TO: Mercedes-Benz Dealer Principals, General Managers, Sales Managers, Service Managers, Parts Managers	FROM: Gregory Gunther, Department Manager, Vehicle Compliance and Analysis, Engineering Services
RE: Recall Campaign Launch Notification Check Transmission Wiring Harness Connector MY 19-22 4-Matic CLS-Class, E-Class, and GT-Class (257, 213, 238, and 290 platform)	DATE: September 30, 2022

Recall Campaign Bulletin

Campaign No. 2022080010, September 2022

Check Transmission Wiring Harness Connector

Figure 4 (*not OK* and OK sealing element)

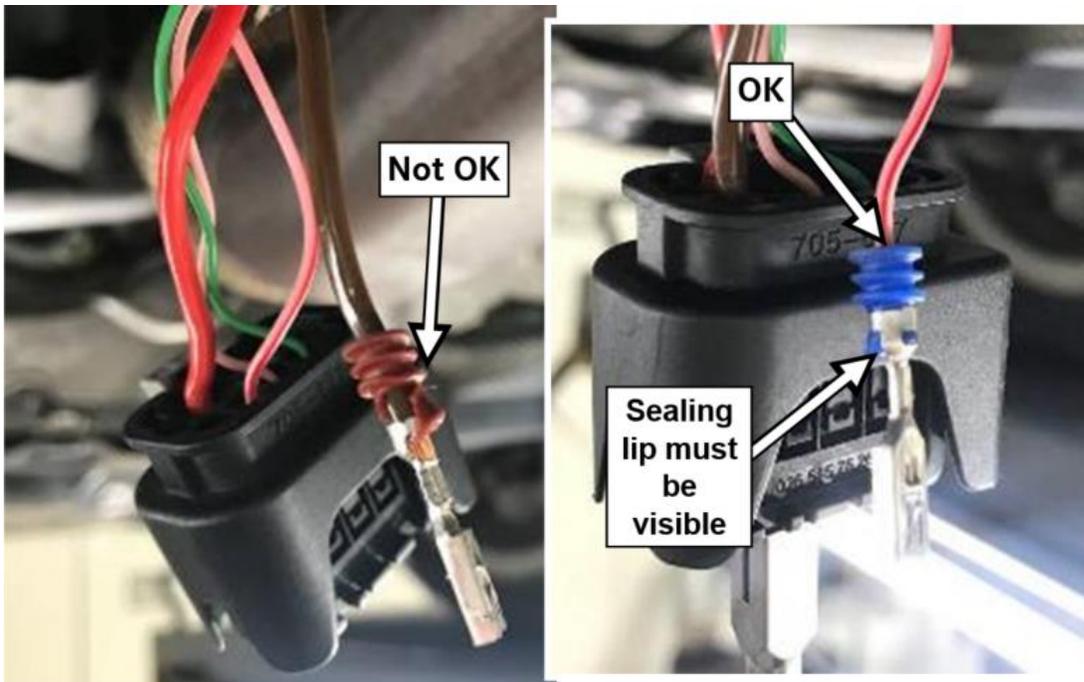
4. Check pins from the **vehicle side** wiring harness (B, figure 2) with the special tool **W 220 589 01 99 63** (figure 3). **Unpin** each individually, check for corrosion and damage such as wire melting or wire sealing lips (figure 4), **and then pin back in**. DO NOT remove all pins at once.

- i** Equivalent commercially available unpinning tools can be used.
- i** **All pins may not** be unpinned from the plug housing **simultaneously**.
- i** The **pins must audibly engage** when reinserted.
- i** No damage or noticeable problems may be visible.
- i** No sealing elements may be damaged or melted at the cables.
- i** Sealing elements must be properly crimped in the cable lug.
- i** See OK figure. Sealing lip must be visible.
- i** Figure 4 shows a *not OK* and OK sealing element!

Figure 5

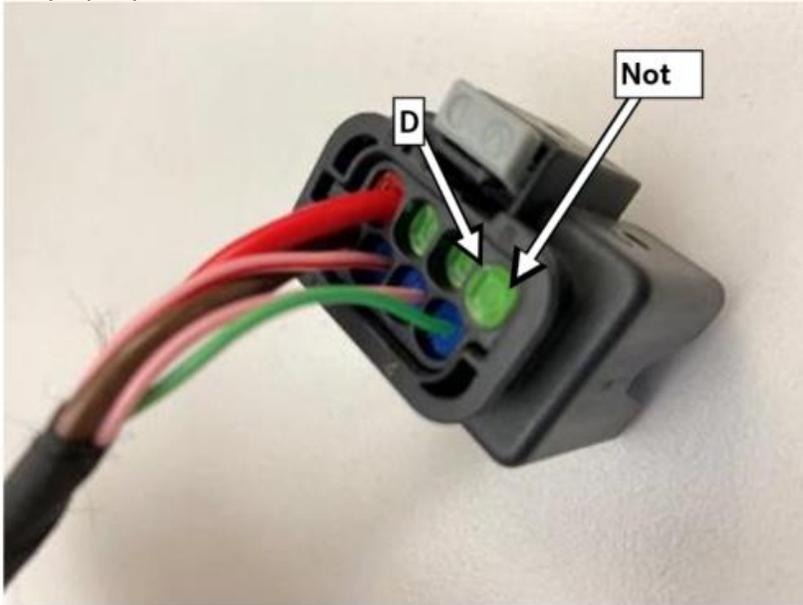
5. Check green blind plugs (D, figure 5) on the rear side of the connector for proper seating, rework if necessary.

i If the connector and the blind plug has no damage and are out of place, the blind plugs need to be pressed into its proper position.

Figure 6

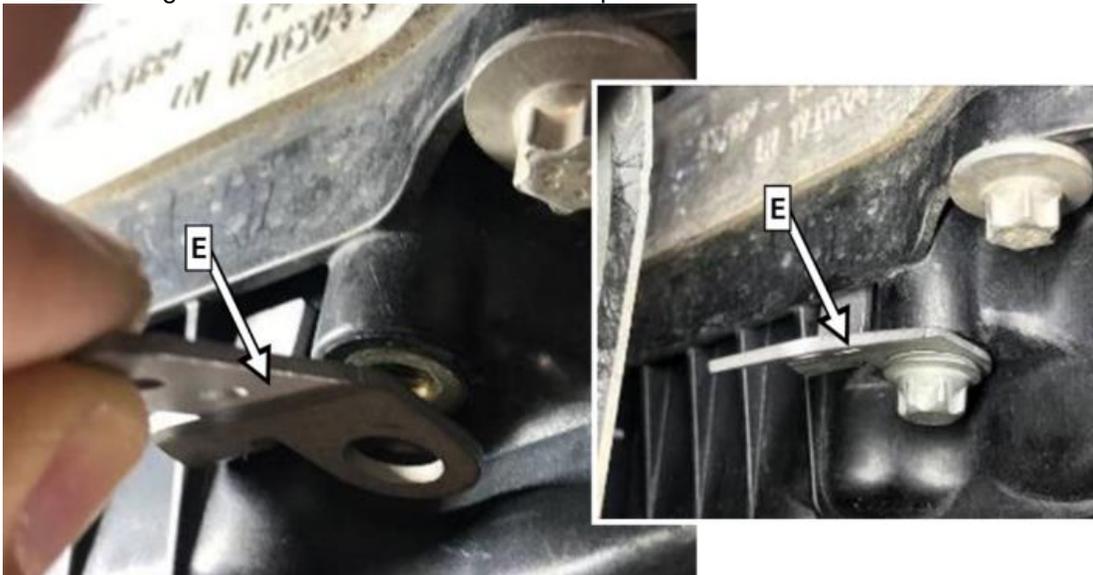
1. Attach new additional wiring harness bracket (E, figure 6) with new screw to transmission oil pan.

i Threaded bushing is already present in the oil pan.

Nm Wiring harness bracket to transmission oil pan **8 Nm**.

Figure 7

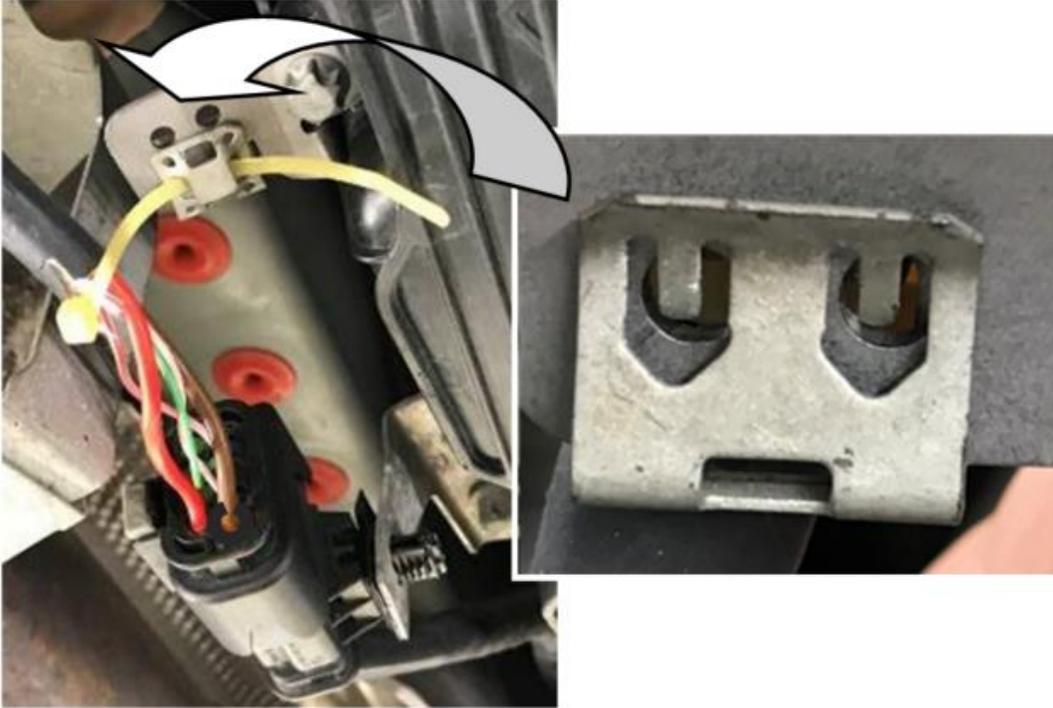
2. Remove retaining clamp and cable tie from the vehicle-side wiring harness.
3. Attach retaining clamp with **new** cable tie (figure 7) to new wiring harness bracket in direction of travel from rear up to end stop.

i Retaining lugs of the retaining clamp engage in the bores of the bracket.
